INDESIT company

Model type:
AVTF109EU

Commercial code:
F033201

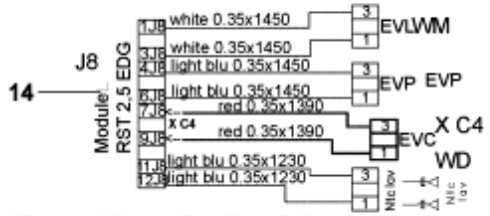
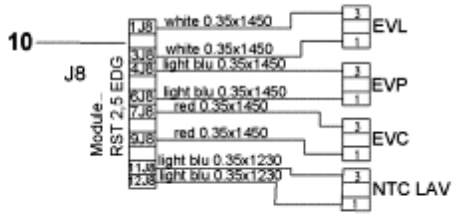
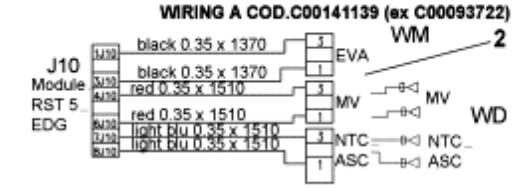
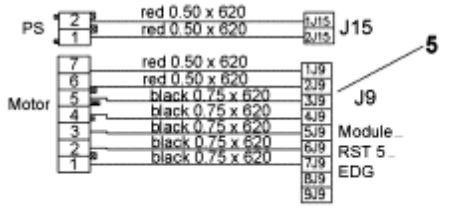
The new wiring when fitted, must be securely attacched to the machine wiring with insulating tape. **Matr. 61116.0001**

WIRING P = DRUM BLOCK COD. C00141995

WIRING P = DRUM BLOCK COD. C00112822

n1040345: Replacement of drum lock button TL EVOII.

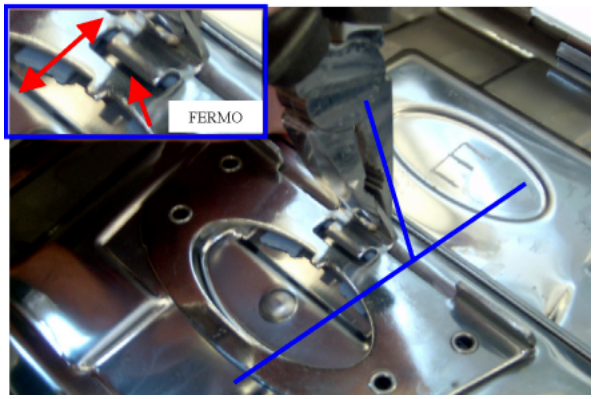
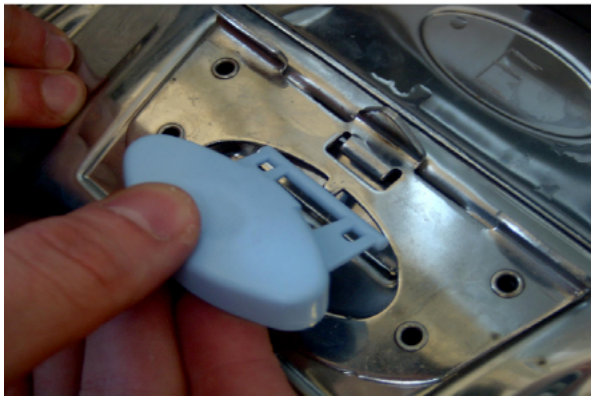
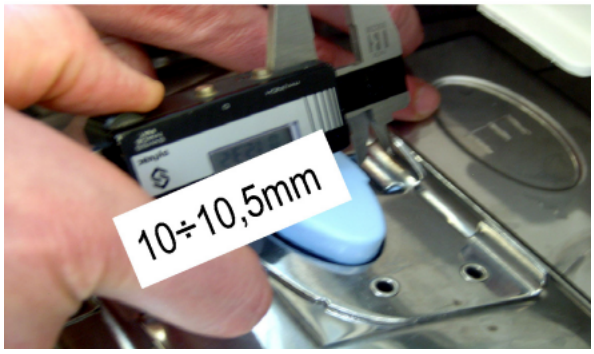
Tools and material needed: pliers, screwdriver, gauge, spring P/N Sat 114989, button P/N Sat 114990.

1) turn the central tip of the catch in the direction shown (FIG.1);

2) bring the tip to a vertical position and ensure that the broken button is disengaged from the catch restraint and can be removed (FIG.2);

3) remove the remaining part of the button with the aid of a screwdriver, taking care not to scratch the doors (FIG.3);

4) pre-assemble spring to button (FIG.4);

5) insert button between catch and door (FIG.5);

6) bring the button into position and arrange the spring in its location in the door (FIG.6);

7) turn the central tip of the catch in the direction shown to return it to its starting position (FIG.7);

8) check the distance between button and catch (FIG.8);

9) check correct operation of the button when opening and closing the doors (slight inclination errors of the catch can result in faulty closing of the doors) (FIG.9).

n1040388: 3.5 three phase module introduced - top-loading Brembate

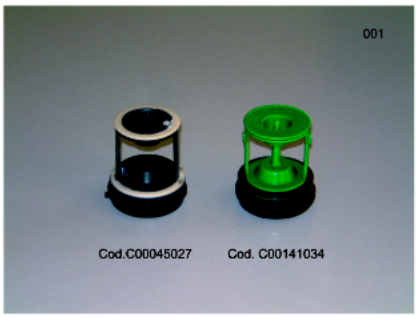
From serial no. 51020.0001 a new 3.05 three phase module has been introduced.
The modification affects the following parts:
-module
-eeprom
-cables (for washing machine with tub lock only)

New parts:
C00265676 three phase module 3.5 - for models with conducibility sensor
C00254298 three phase module 3.5 - for models without conducibility sensor
C00141995 - tub lock cables

Premodification parts:
C00108982 - three phase module
C00112822 - tub lock cables

The spare parts warehouse is not managing the premodification module C00108982, so the new 3.5 C00254298/C00265676 can be fitted on the premodification models using the new setting file the new tub lock cables (on products with tub lock).

ATTENTION!! USING THE NEW MODULE ON PREMODIFICATION MODELS, WHEN YOU DOWNLOAD THE SETTING FILE WITH PALM YOU MUST SELECT A SERIAL NUMBER AFTER THE MODIFICATION.

n4008f00: Thermic link wire removed on three-phase motor

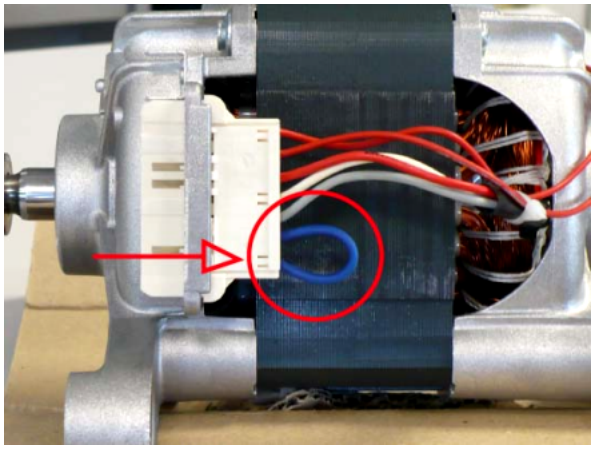
Attention!
When you assist the premodification models using the new motor code you MUST use the thermic link wire code C00265838.

TRIPHASE P32 46 L TOP LOADING
C00265832 new motor without thermic link wire - C00262375 premodification motor with thermic link wire

In the attached image you can see the fixing of thermic link wire in the motor therminal box.
